City of Tualatin

ARCHITECTURAL REVIEW FINDINGS AND DECISION

Case #:	AR-15-04
Project:	Trail Blazers Facility Addition
Location:	7325 SW Childs Rd (Tax Lot 2S1 24AB 00200)
Applicant:	Joshua Peterson, GBD Architects Inc. (503-224-9656; Project No. 20086635); Chris Oxley, Portland Trail Blazers

SHEET TITLE
 STORMWATER
 PLAN

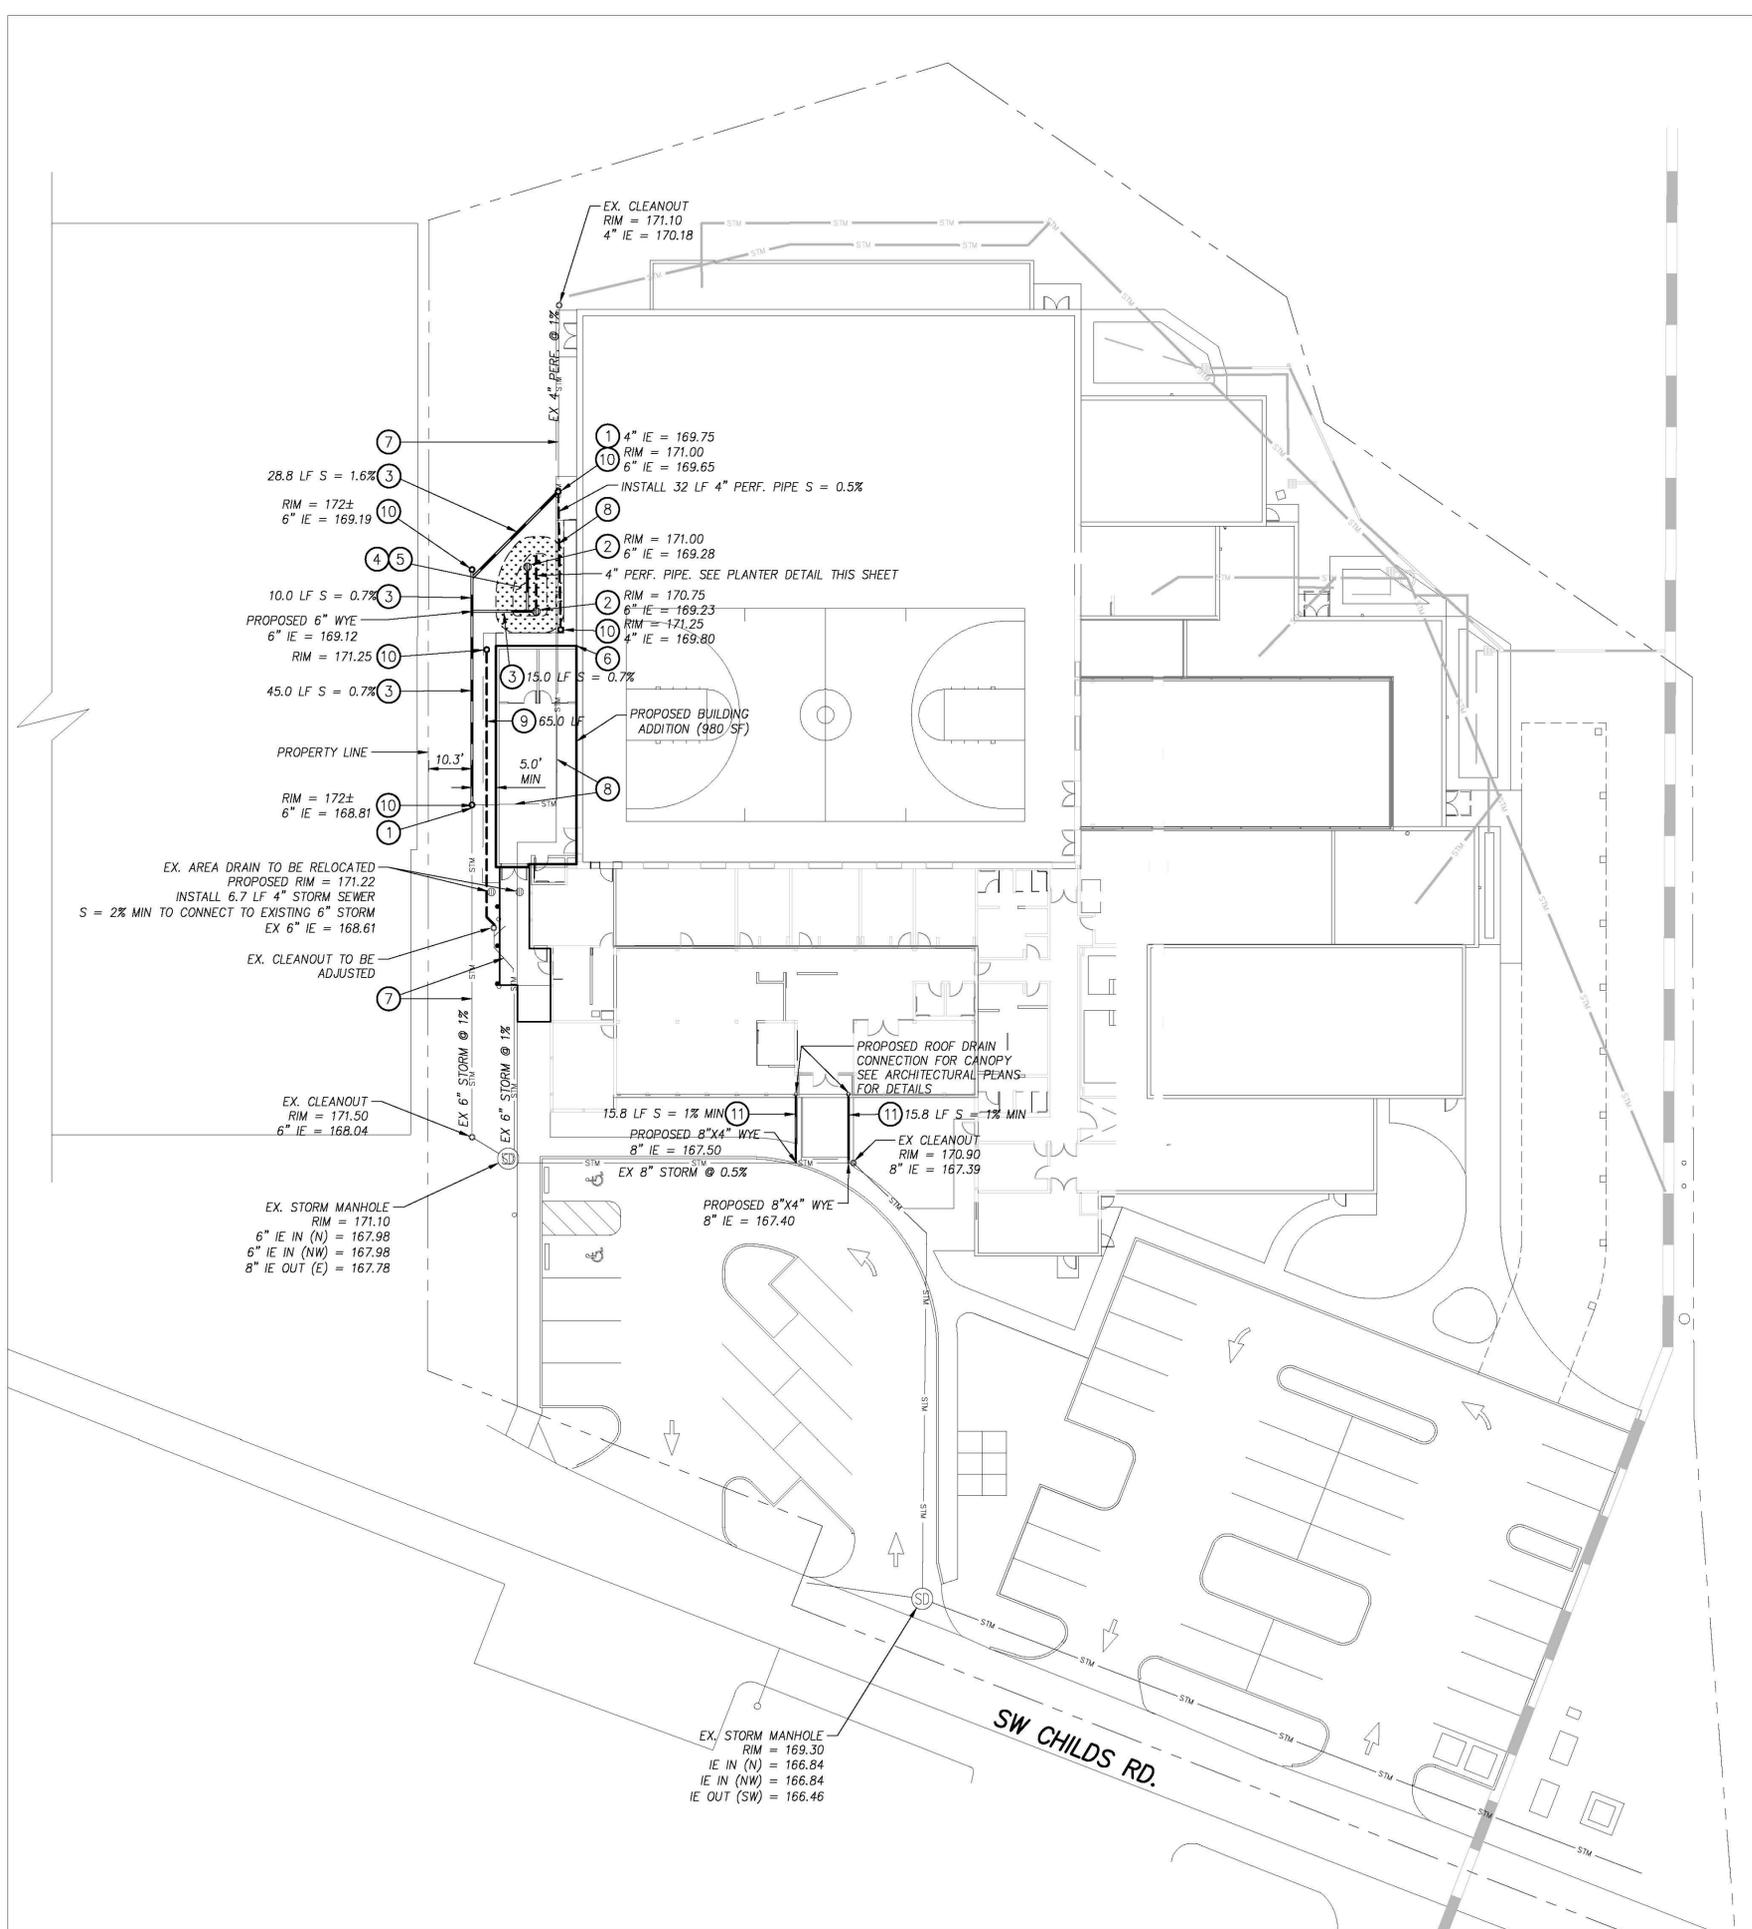
The existing stormwater system conveys stormwater from the entire site to an existing treatment and detention facility to the south on TLID 2S124AB00500. The submitted plans propose treatment and detention for the building addition within one LIDA facilities adjacent to the building. The facilities release to a proposed new lateral to a 30-inch public stormwater line in a public easement on the east side of the lot.

The applicant has submitted treatment and conveyance calculations that show adequate treatment and release rate for the new facilities. The applicant has submitted final stormwater plans. This is acceptable.

SITE PLAN -
 ROOF PLAN

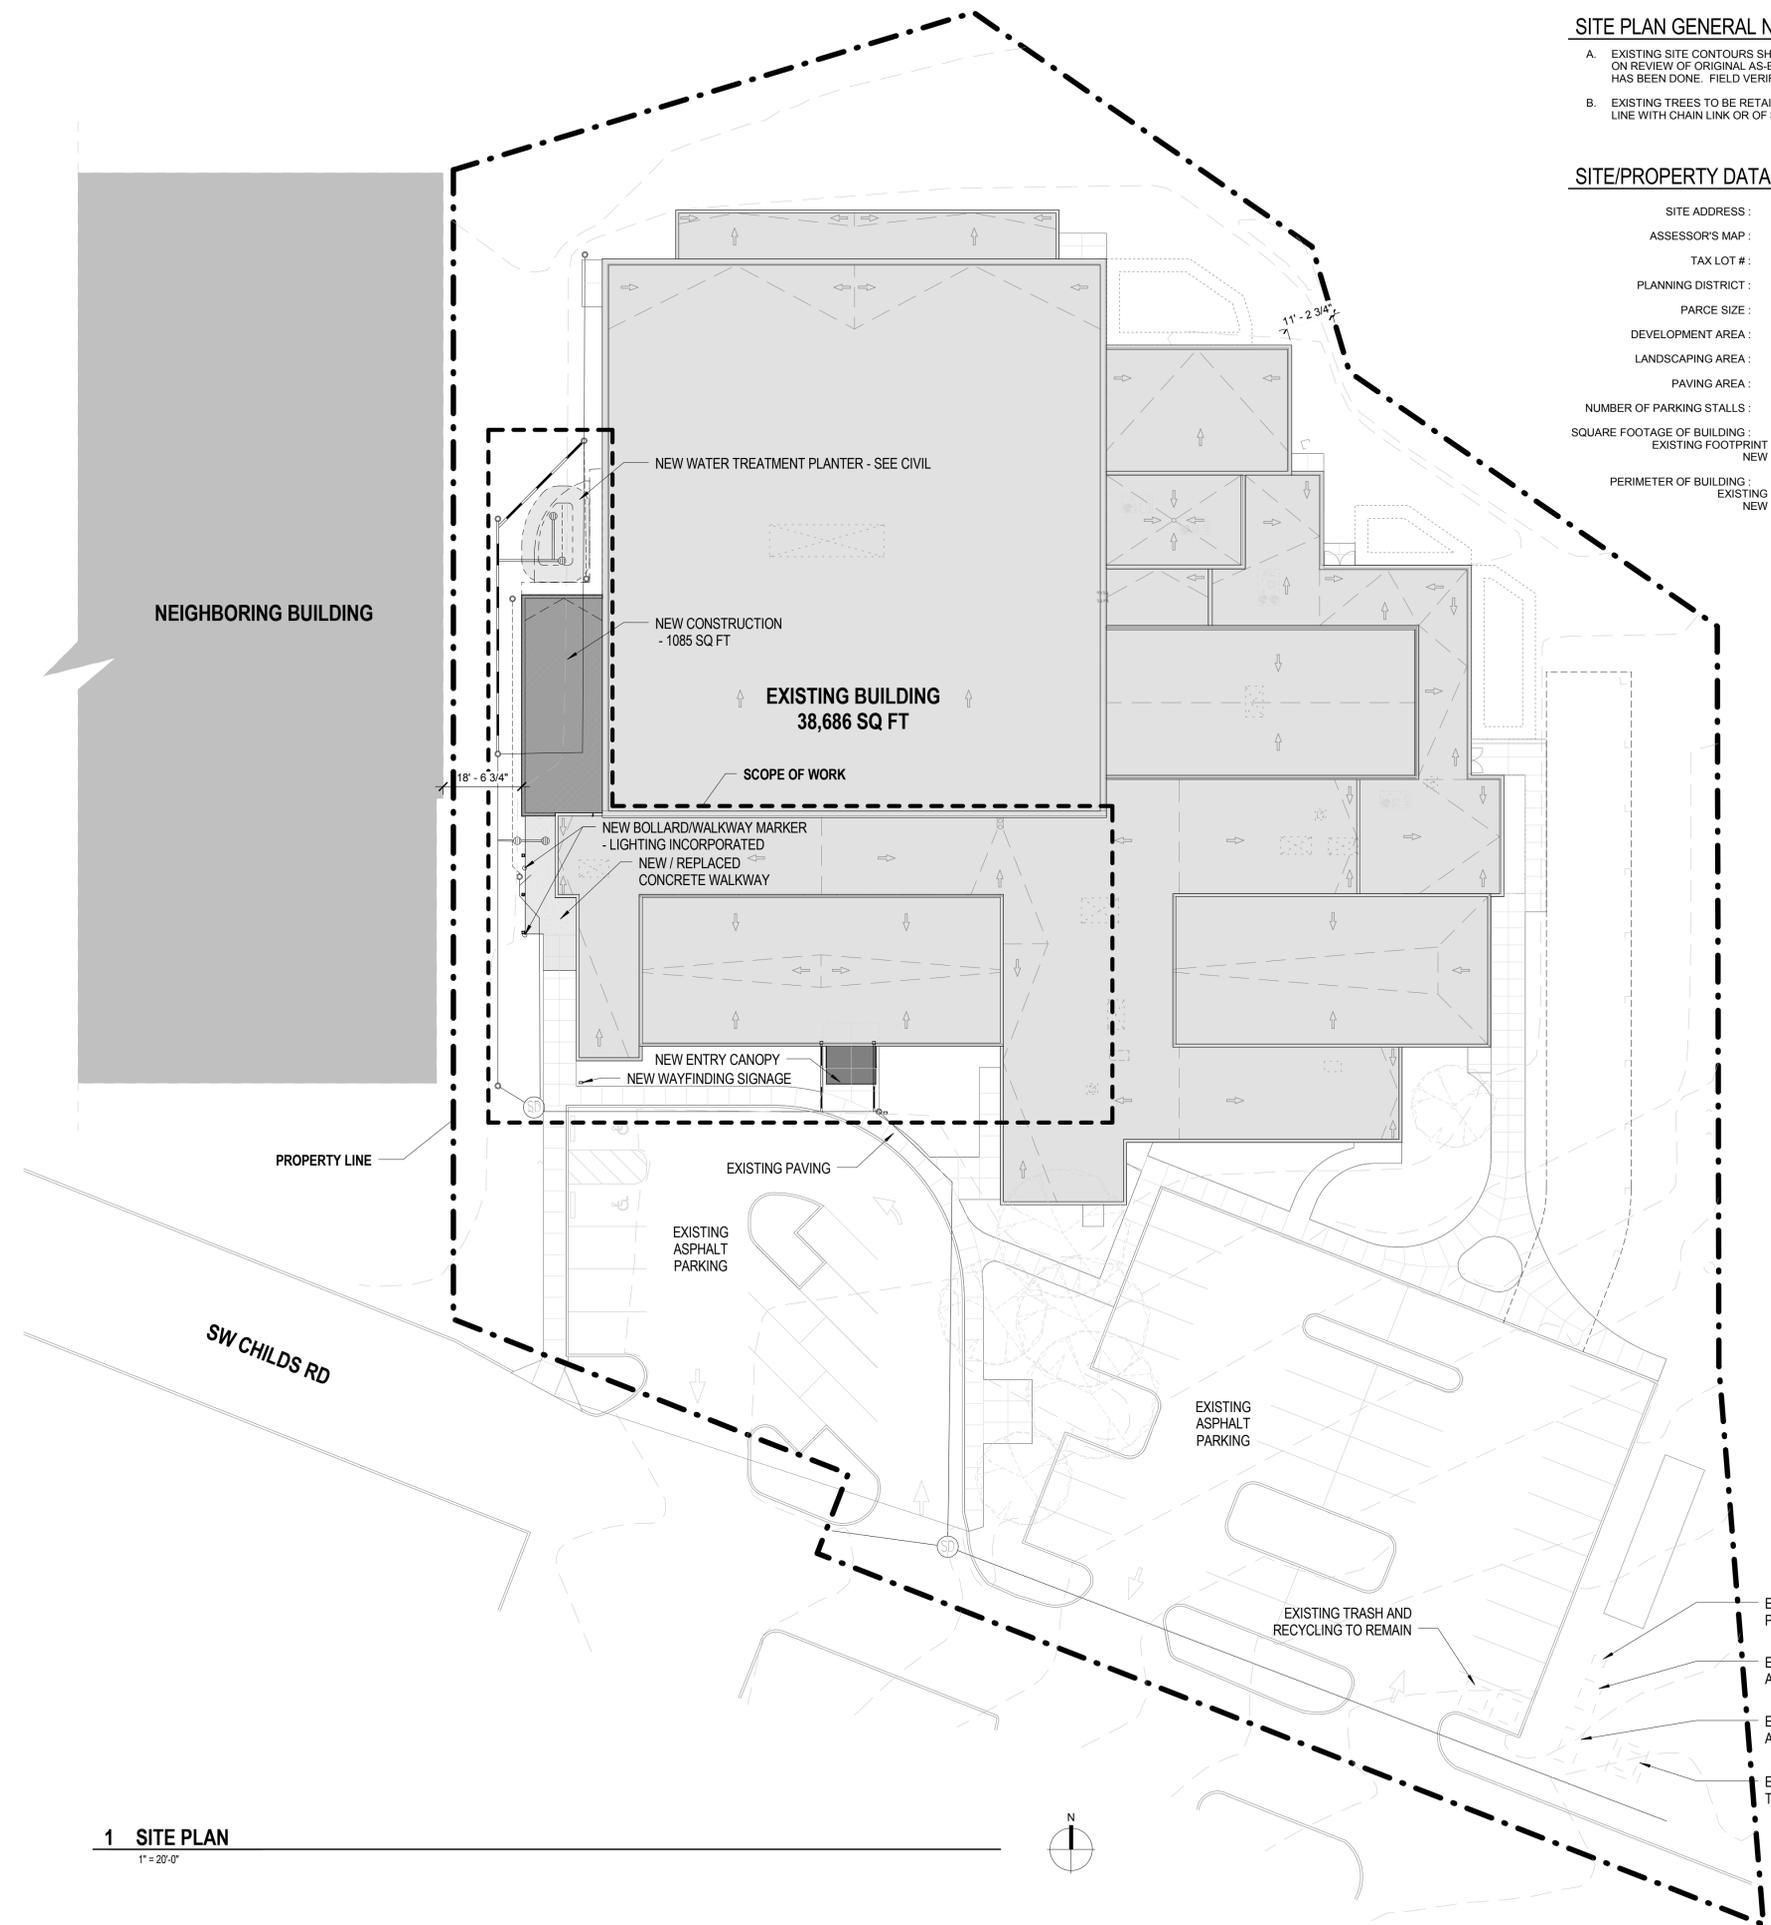
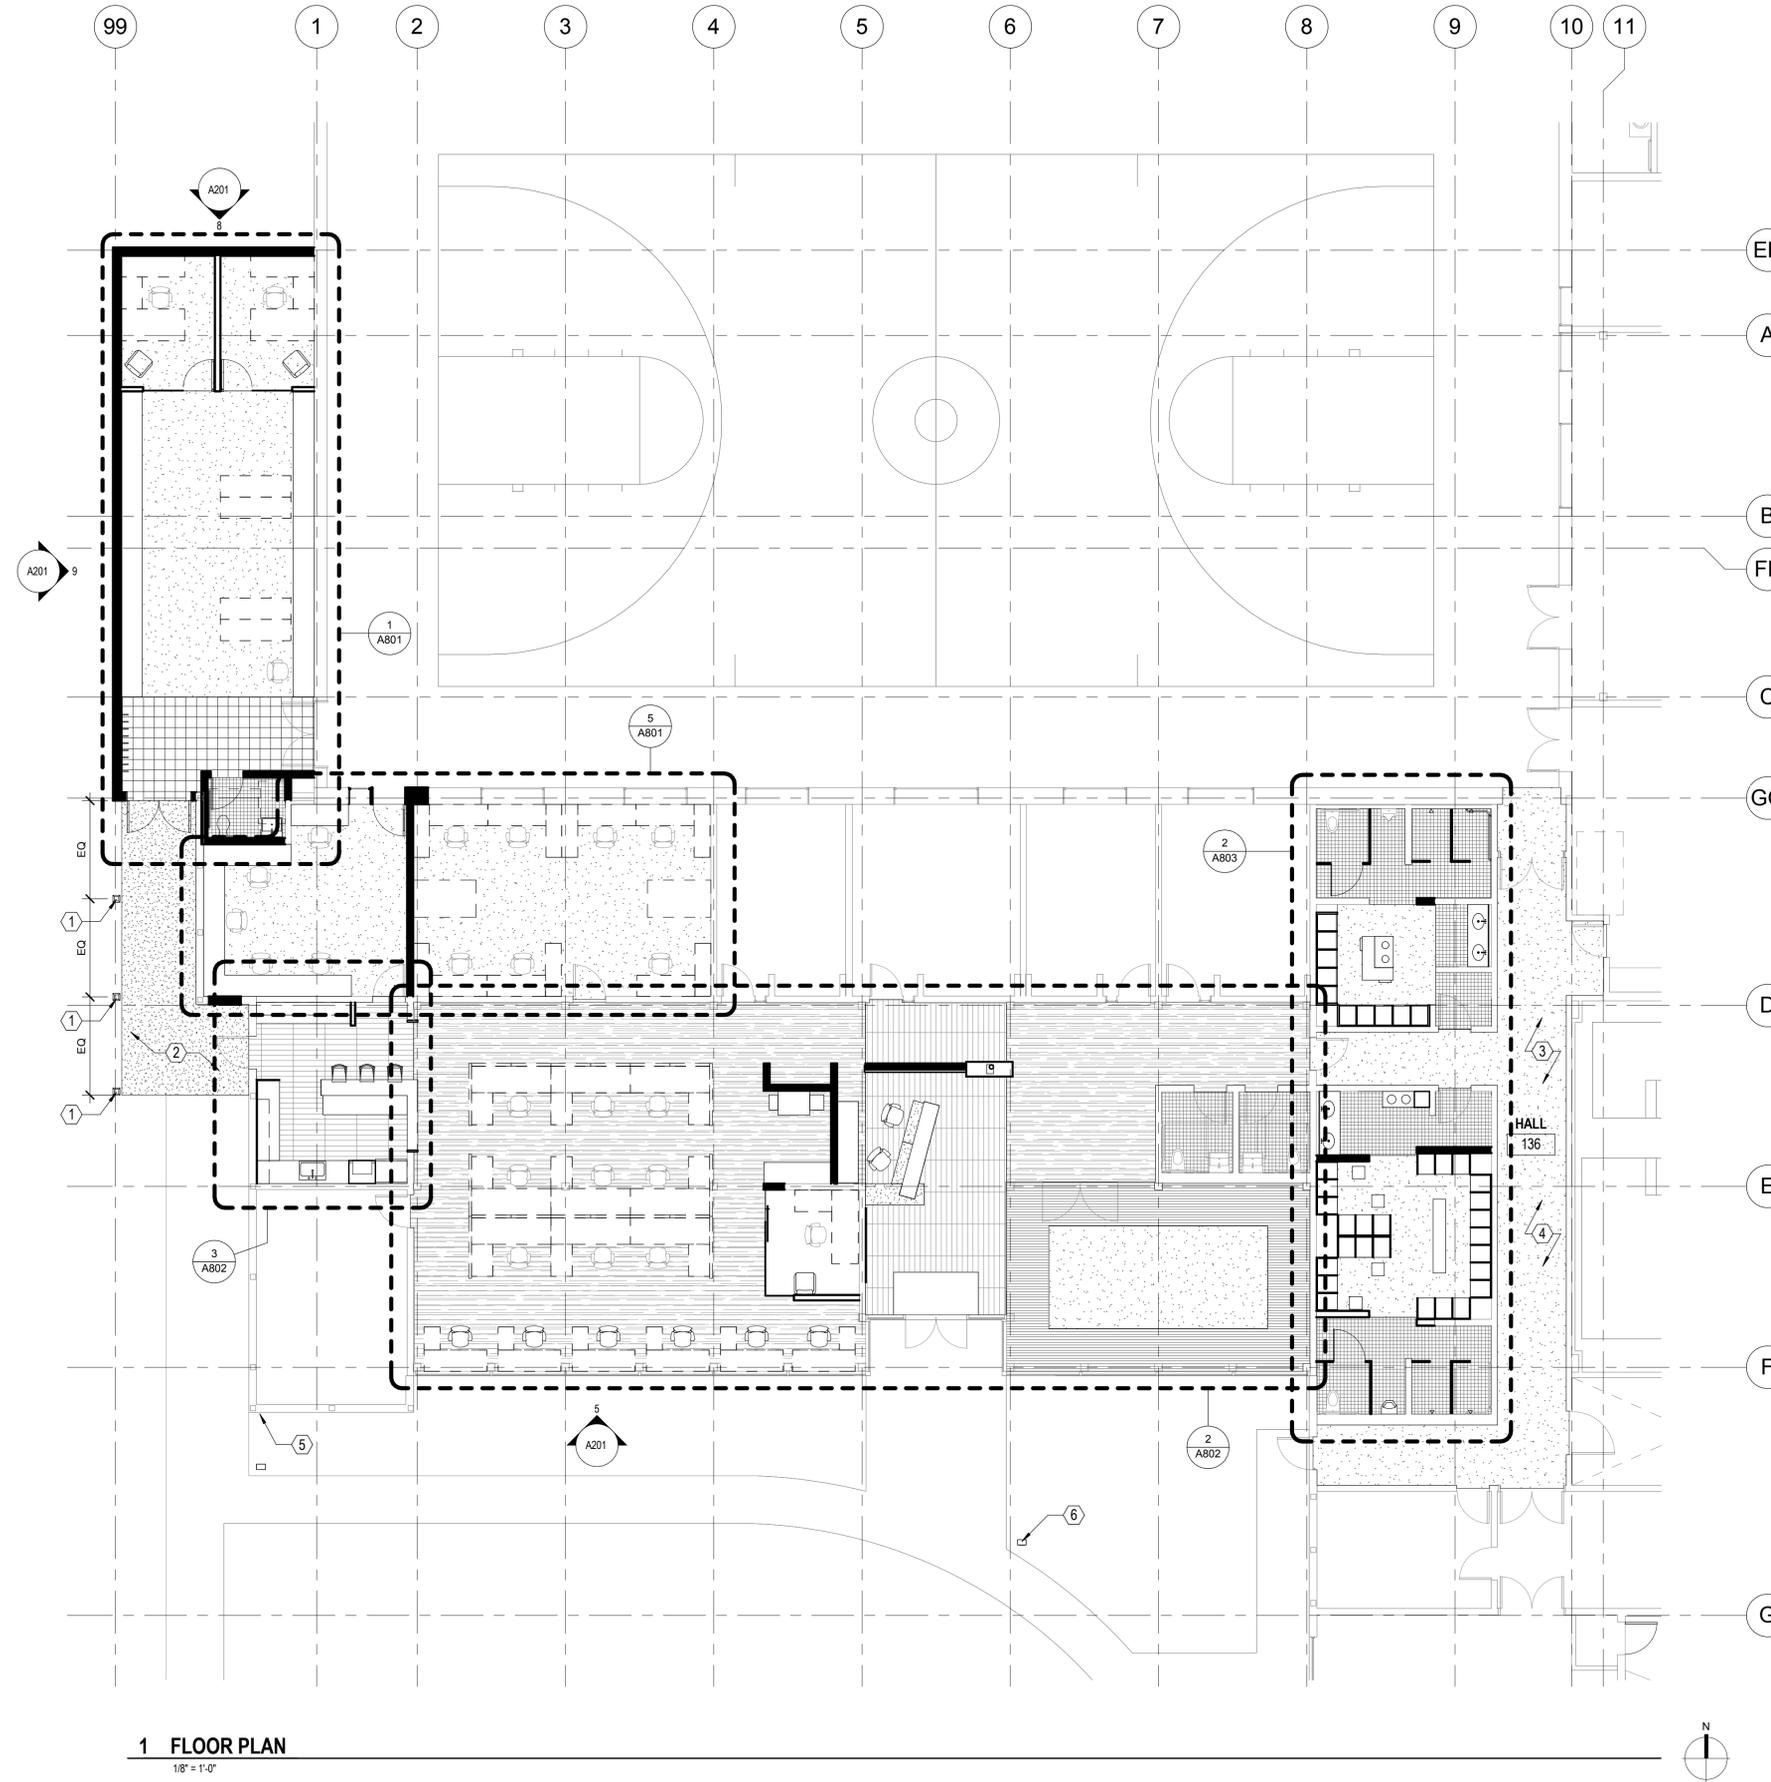
Because the proposed site and roof plan (Sheet A001) illustrates and notes no new at-grade or rooftop mechanical equipment, the requirement is not applicable.

Because the site development area within Lot 200 is not within the Core Area Parking District, and the applicant proposes no dedication for a greenway or natural area and none is required, the minimum area requirement for landscaping is 15%. The proposed site plan (Sheet A001)

The site plan (Sheet A001) and existing landscape plan (L001) together show removal of some southwest side yard shrubbery to make way for the building addition. Because the side yard remains planted with trees and groundcover, the requirement is met.

The site plan (Sheet A001) notes that existing trees are to be retained through such protections, meeting the requirement.
